UNITED STATES PATENT AND TRADEMARK OFFICE

APPLICATION NO.	FILING DATE	FIRST NAMED INVENTOR	ATTORNEY DOCKET NO.	CONFIRMATION NO.
10/647,837	08/25/2003	Robert D. Foxwell	51449-00211	2888

Office Action Summary	Application No.	Applicant(s)	
	10/647,837	FOXWELL, ROBERT D.	
	Examiner	Art Unit	
	Gay Ann Spahn	3673

DETAILED ACTION

VE-VE boat ramp sales sheet showing three models

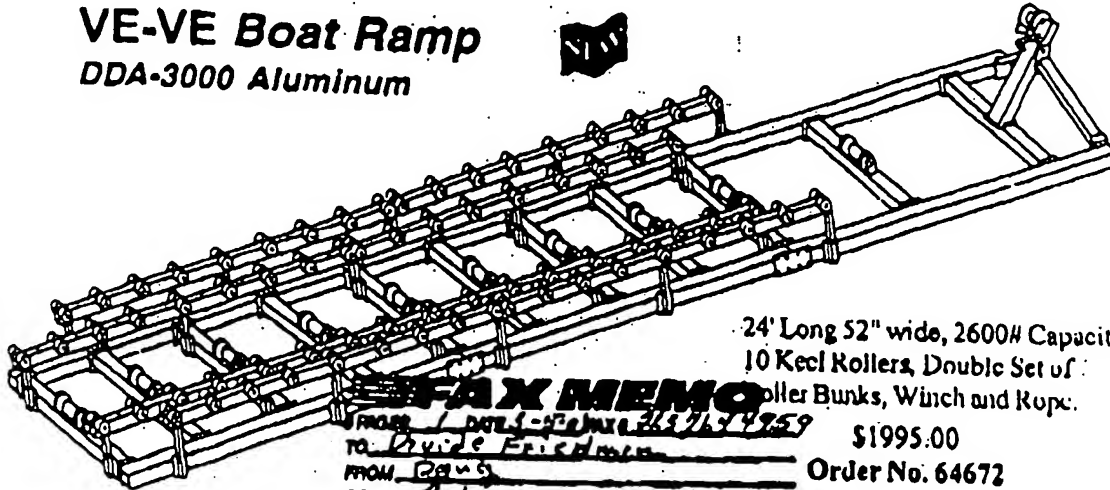
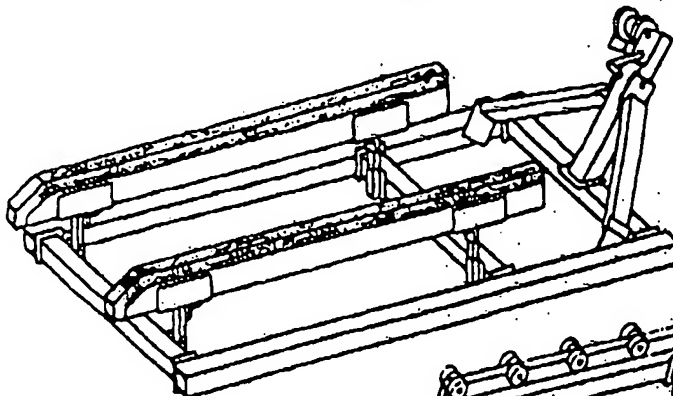
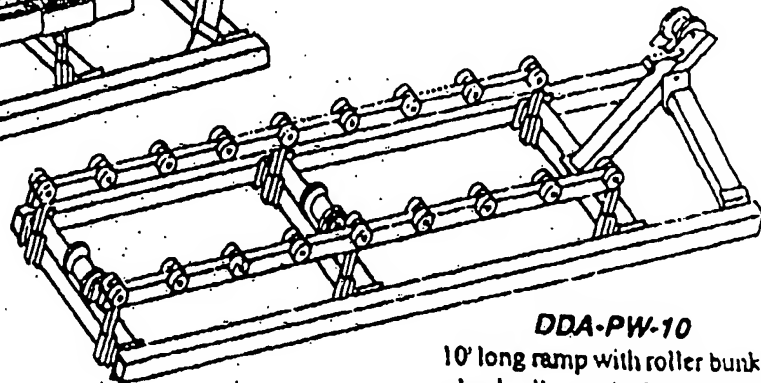
Claim 12 is rejected under 35 U.S.C. 103(a) as being unpatentable over Graf, as applied to claims 7 and 11 above, and further in view of VE-VE boat ramp sales sheet showing three models (Applicant submitted prior art entitled Document No. 4-2 on Information Disclosure Statement (IDS) filed in parent application U.S. Patent Application Serial Number 10/113,961 (now U.S. Patent No. 6,637,975) on March 29, 2002).

VE-VE boat ramp sales sheet showing three models discloses three models of watercraft ramps each having a loading assembly with a support beam mounted rigidly to the transverse stabilizer bar.

It would have been obvious to one of ordinary skill in the art at the time the invention was made to modify the watercraft ramp of Graf by rigidly mounting the winch support beam of the loading assembly to the transverse stabilizer bar as taught by VE-VE boat ramp sales sheet showing three models in order to lower the center of gravity

of the connection of the support beam to the watercraft structure and thereby prevent the watercraft ramp structure from easily tipping over.
